Access Compliance Report

Public Rights-of-Way

(Curb Ramps)

Intersection ID: 50614	Main Street: PADDLE_OAK_RD	Cross Street: BALSAM_BAY_RD	Location: SW
ADA ID: 629B78FF739D	Ramp Type: Perp	Initial Pass/Fail: Fail	Overall Compliance: No
Severity Score: 21.25			
Codes/Mitigation Info/Possible Solution		Field Measurements/Component Compliance

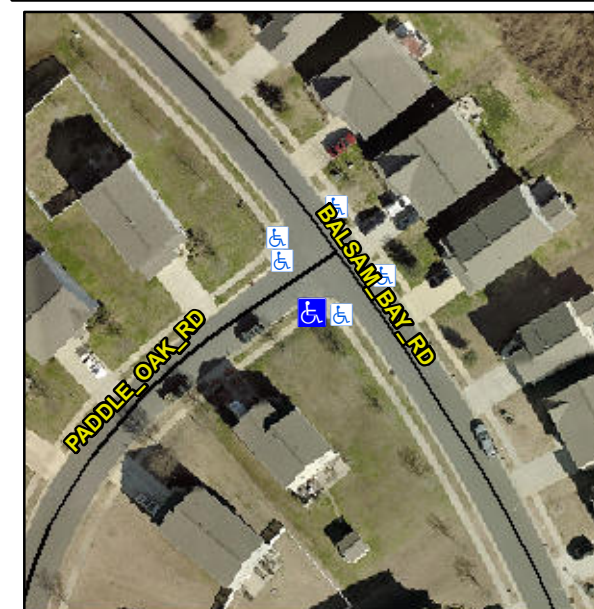
R304.5.1, R304.2.2

Compliance	Description	Data	Compliance	Description	Data
N/A	Ramp Length (in)	48.0	No	Ramp Slope (%)	9.9
No	Ramp Width (in)	47.5	Yes	Ramp XSlope (%)	0.3
N/A	Flare Type LT	N/A	N/A	Flare Type RT	N/A
N/A	Flare Slope LT (%)	N/A	N/A	Flare Slope RT (%)	N/A
N/A	Flare Traversable LT?	N/A	N/A	Flare Traversable RT?	N/A
N/A	Landing Length (in)	N/A	N/A	DWS Provided?	N/A
N/A	Landing Width (in)	N/A	N/A	DWS Contrast?	N/A
N/A	Landing Slope (%)	N/A	N/A	DWS Length (in)	N/A
N/A	Landing X Slope (%)	N/A	N/A	DWS Full Width?	N/A
N/A	Landing Curb? (Y/N)	N/A	N/A	DWS Offset (in)	N/A
N/A	Shared Landing?	N/A			
N/A	Gutter Ponding?	N/A	N/A	Gutter Slope (%)	N/A
N/A	Gutter Lip Ht (in)	N/A	N/A	Gutter X Slope (%)	N/A
N/A	Painted X Walk1?	No	N/A	Painted X Walk2?	N/A
	X Walk 1 Direction	To N		X Walk 2 Direction	N/A
N/A	X Walk 1 Width (in)	N/A	N/A	X Walk 2 Width (in)	N/A
	X Walk 1 Slope (%)	1.4		X Walk 2 Slope (%)	N/A
	X Walk 1 X Slope (%)	0.2		X Walk 2 X Slope (%)	N/A

Remove & Replace Entire Ramp.
